# Access Compliance Report

## Public Rights-of-Way

| Intersection ID: 46663                  | Main Street: DONATELLO_AV | Cross Street: N_DAVIDSON_ST             | Location: SW           |
| ADA ID: 111E4D6E6ABA                    | Ramp Type: Perp           | Initial Pass/Fail: Fail                 | Overall Compliance: No |

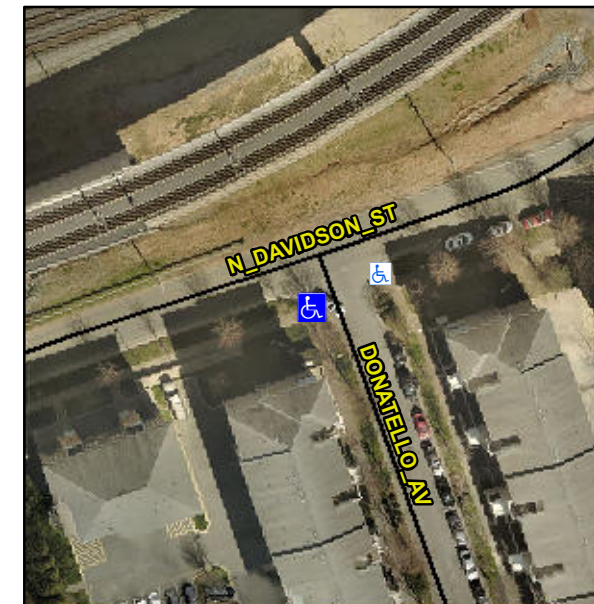
**Not Found, R304.5.1, R304.2.2, R304.5.3**

| Compliance | Description           | Data | Compliance | Description                 | Data |
|------------|-----------------------|------|------------|-----------------------------|------|
| N/A        | Ramp Length (in)      | 60.0 | No         | Ramp Slope (%)              | 9.9  |
| No         | Ramp Width (in)       | 45.0 | No         | Ramp XSlope (%)             | 2.3  |

**Remove & Replace Entire Ramp.**
